SUBJECT: Savannah River Site's Responses to the Regulatory Comments on the Biennial Effectiveness Monitoring Report (EMR) for Monitored Natural Attenuation (MNA) at the C-Area Burning/Rubble Pit (131-C) and Old C-Area Burning/Rubble Pit (NBN) Operable Unit (U) January 2017 through December 2018 (SRNS-RP-2019-00327, Revision 0, June 2019) SEMS Number: 31

**SRS responses to the SCDHEC Comments on the
Biennial Effectiveness Monitoring Report (EMR) for Monitored Natural
Attenuation (MNA) at the C-Area Burning/Rubble Pit (131-C) and Old C-Area
Burning/Rubble Pit (NBN) Operable Unit (U) – January 2017 through December
2019, SEMS Number: 31 (SRNS-RP-2019-00327, Revision 0, June 2019) received
June 28, 2019.**

Figure 1. CRP 3D TCE Trends

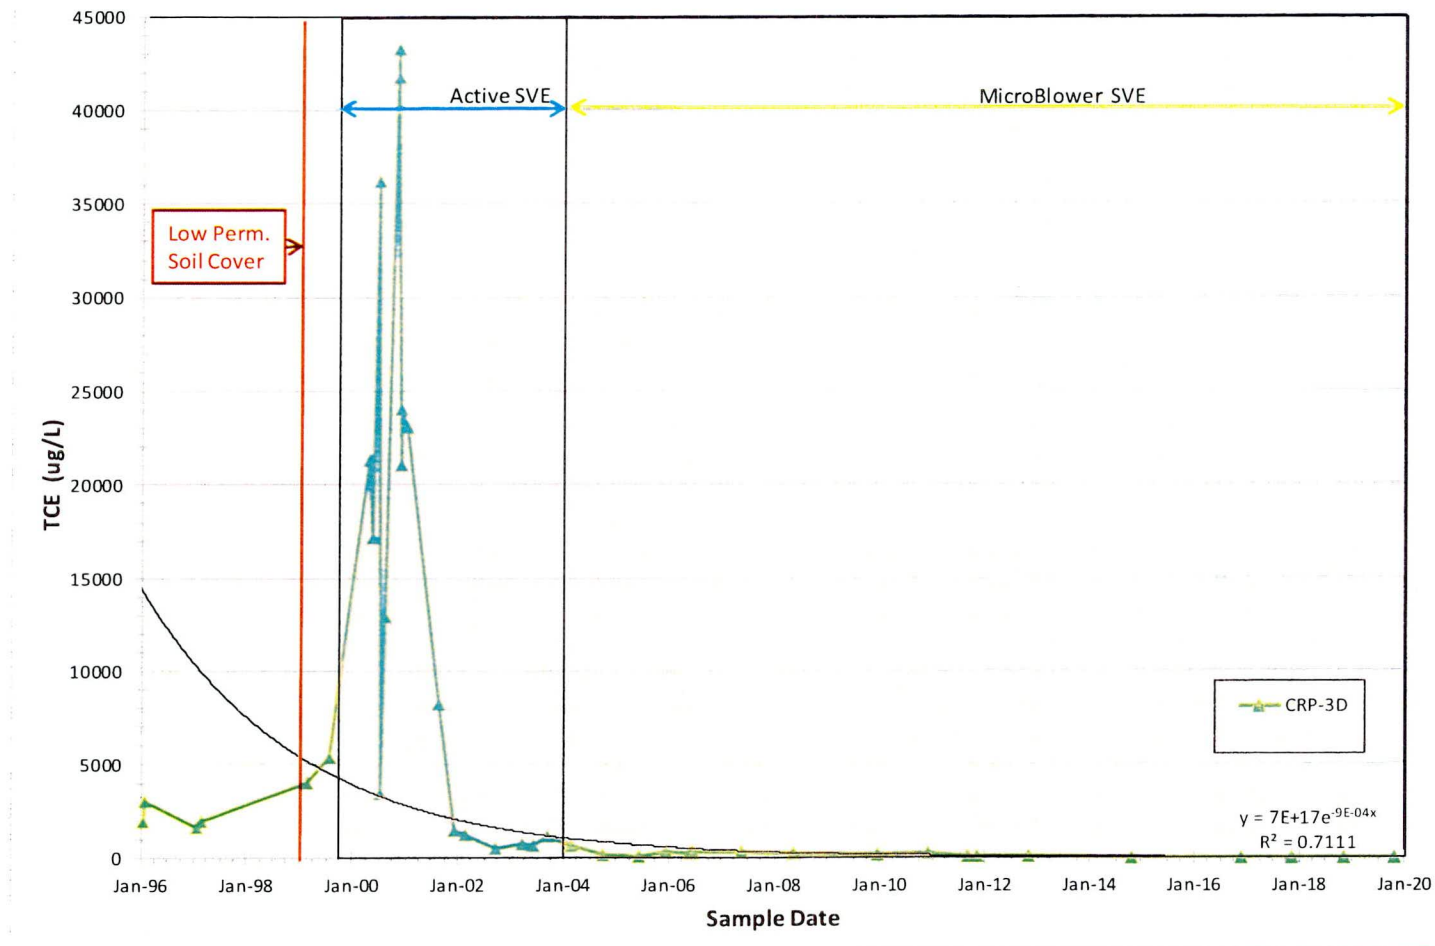
1. The conclusions regarding the effectiveness of the remedy provided in Biennial Effectiveness Monitoring Report (EMR) for Monitored Natural Attenuation (MNA) at the C-Area Burning/Rubble Pit (131-C) and Old C-Area Burning/Rubble Pit (NBN) Operable Unit (U), January 2017 through December 2018, SEMS Number: 31, SRNS-RP-2019-00327, Revision 0, June 2019 (Biennial Report) are not fully supported. In Section 5.0, Summary, the text on Page 18 of 32 states that during the 2017-2018 sampling period, overall VOC concentrations continued to decrease in most monitoring wells. A statistically significant demonstration of the data is not provided to support such a statement. For example, although time-series plots are provided, best-fit trend lines showing an increase or decrease of concentrations over time are not presented. In addition, statements regarding trend should be supported by a statistical analysis of the data per EPA guidance (i.e., Data Quality Assessment: Statistical Methods for Practitioners, EPA QA/G-9S, U.S. EPA 2006). Revise the Biennial Report to include best-fit trend lines on time-series plots and identify statistically significant trends using methods (e.g., Mann-Kendall) per the guidance referenced above.

The addition of trendlines to the time-series plots will provide very limited additional value to understanding of the overall plume behavior over time. This is due to what is likely a complex release history over time from the source zone, spatial heterogeneity in the dissolved contaminant plume, and ongoing physical processes such as back diffusion from low permeability zones. It is important to note that as the TCE hot spot created in 1998 moves through the aquifers TCE concentrations at monitoring wells (e.g. CRP 20CU) will increase and then decrease similar to that observed in well CRP 3D. Most trendline formulas do not fit these data very well (Figures 1 and 2).

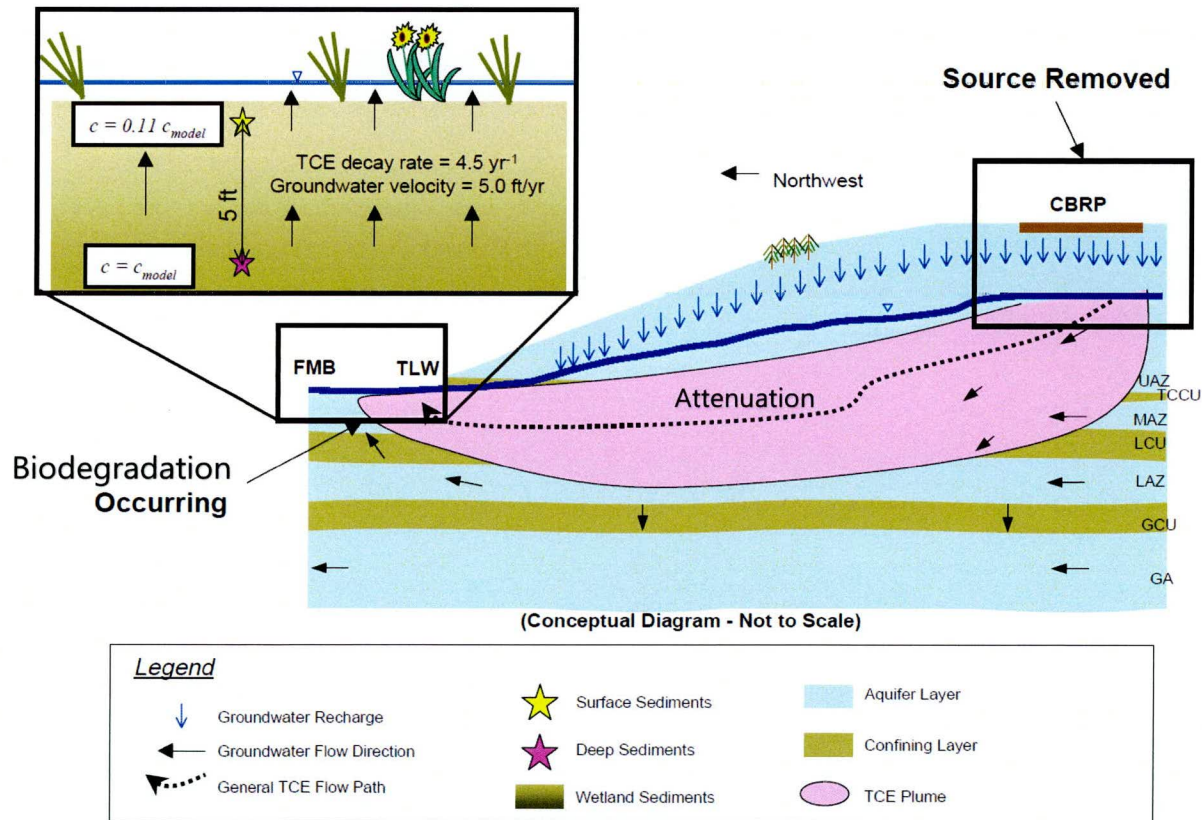
1. Figure 3, CBRP OU LUC Boundary, page 25. Monitoring well CRP 6DR is labeled on this figure, but the well location is not marked. Please include.

The well marker symbol will be included on the equivalent Figure 3 in the 2021 CBRP OU EMR.
